Planning Proposal to Rezone and Amend Minimum Lot Size and Lots at 292 Rosemont Road, Goulburn (PP_2024_101; REZ/0006/2122)

ATTACHMENT 1 - DETAIL

Map 1. 292 Rosemont Road, Goulburn: Strategic Land and Water Capability Assessment (SLWCA) for Residential Unsewered Lots (4000 m² – 2 ha).

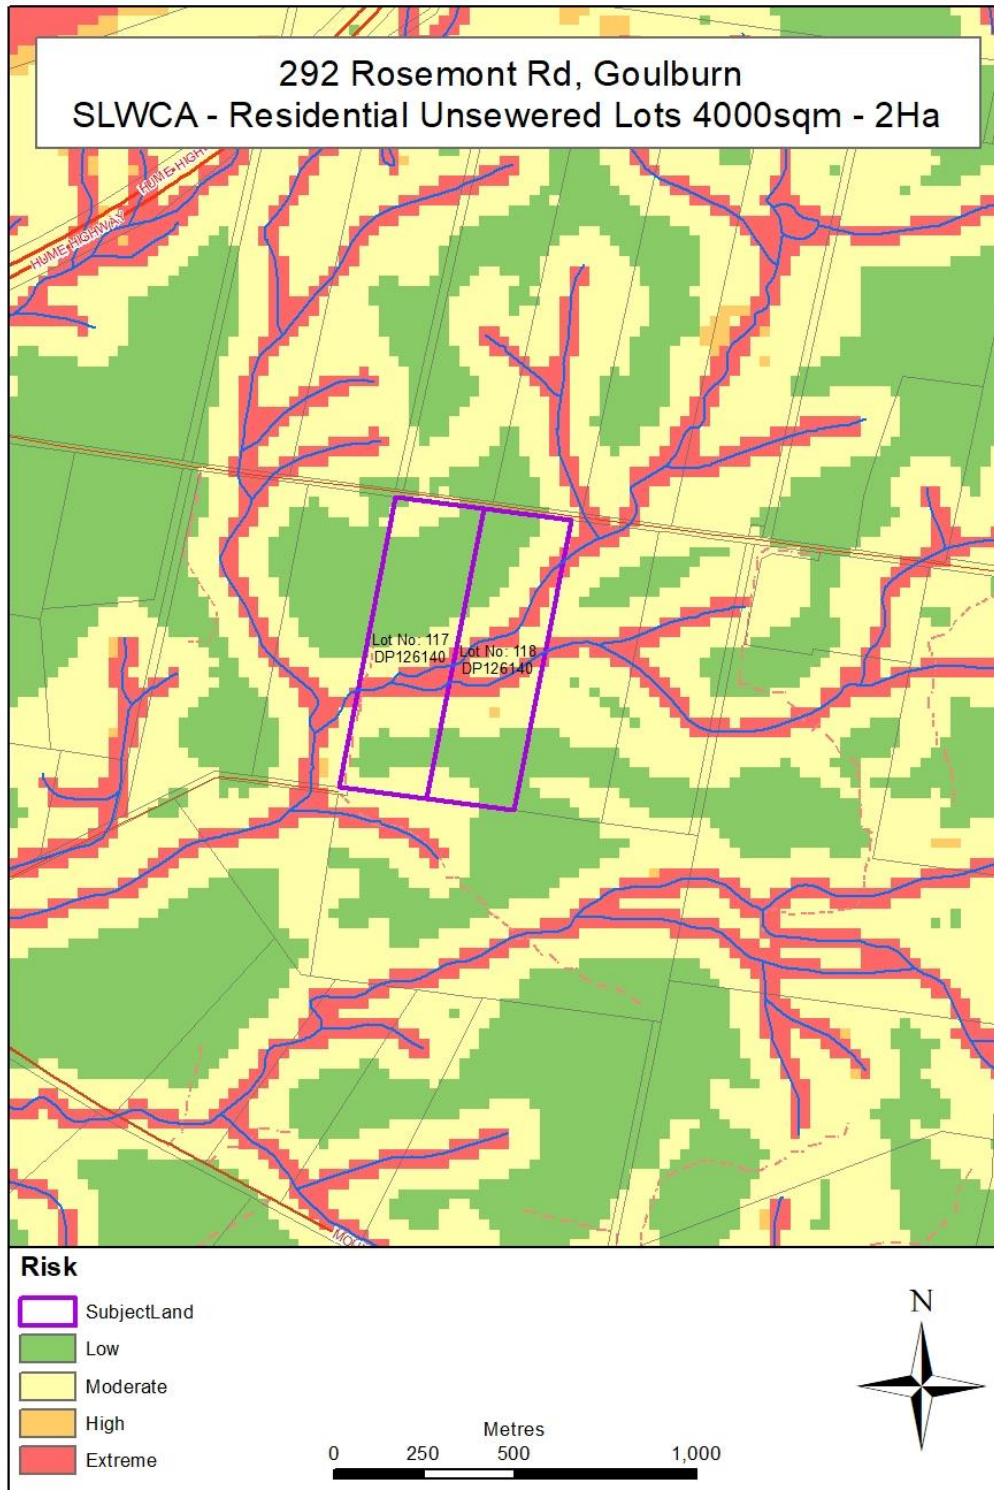
We provide a copy of the SLWCA for Residential Unsewered Lots (4,000 m² to 2 ha) in Attachment 2. This is the most appropriate SLWCA given the intended land use for the site. Please note that while locations and distance from waterways is factored into the SLWCA analysis, flood risk is not factored into the SLWCA modelling and risk outputs.

The SLWCA shows that the water quality risk for the site varies from LOW to EXTREME. Area of EXTREME risk are associated with the watercourses. Areas of EXTREME risk have a VERY LOW capability for unsewered development. These areas are also associated with the areas proposed for C2 zoning. The remaining areas are generally associated with a LOW or MEDIUM risk to water quality. Areas of LOW risk have a HIGH capability for unsewered residential development. Areas of MODERATE risk have a MODERATE capability for unsewered development. The areas in the north of the site that are proposed for RU5 zoning have a LOW to MODERATE capability for unsewered development. The proposed zoning is therefore largely compatible with the water quality risks for the site as generated by the SLWCA analysis and outputs.
